ADDENDUM NO. 1 TO PROJECT NO. 44627

**CONSTRUCTION WORK, PLUMBING WORK, ELECTRIC WORK
UPGRADE OBSERVATION CELLS
FIRST FLOOR, BUILDING NO. 35
WENDE CORRECTIONAL FACILITY
3040 WENDE ROAD
ALDEN, NY**

May 11, 2015

8
CELL DOOR TYPICAL DETAIL
 SCALE: NOT TO SCALE

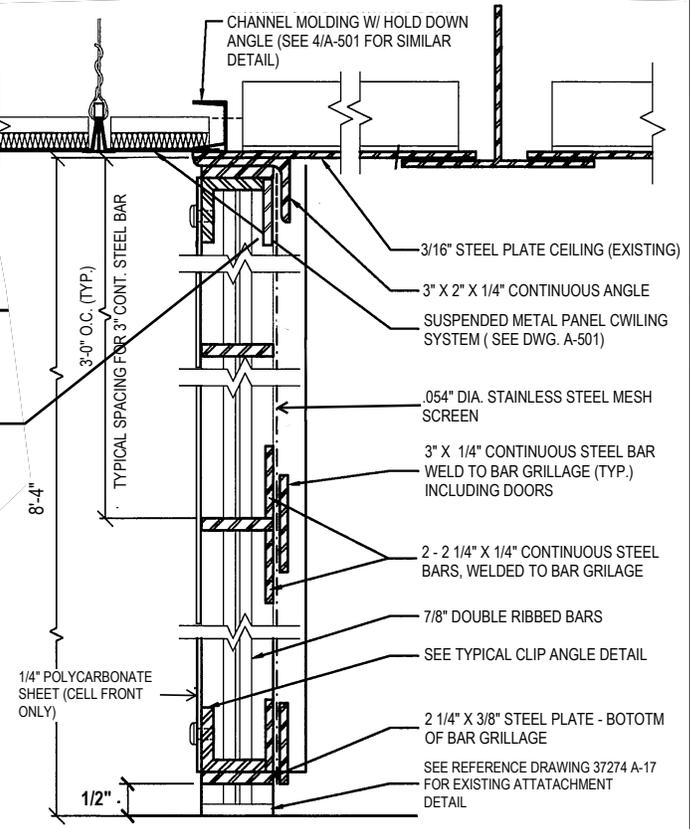
4. Drawing No. A-501
 - a. TITLE BLOCK: Change Project no. '44267-C' to read '44627-C'.
 - b. DETAIL 8/A501: Replace 'DETAIL 8' per attached, revised detail on drawing no. ADD-1.
 - c. DETAIL 9/A501: Replace 'DETAIL 9' per attached, revised detail on drawing no. ADD-1.
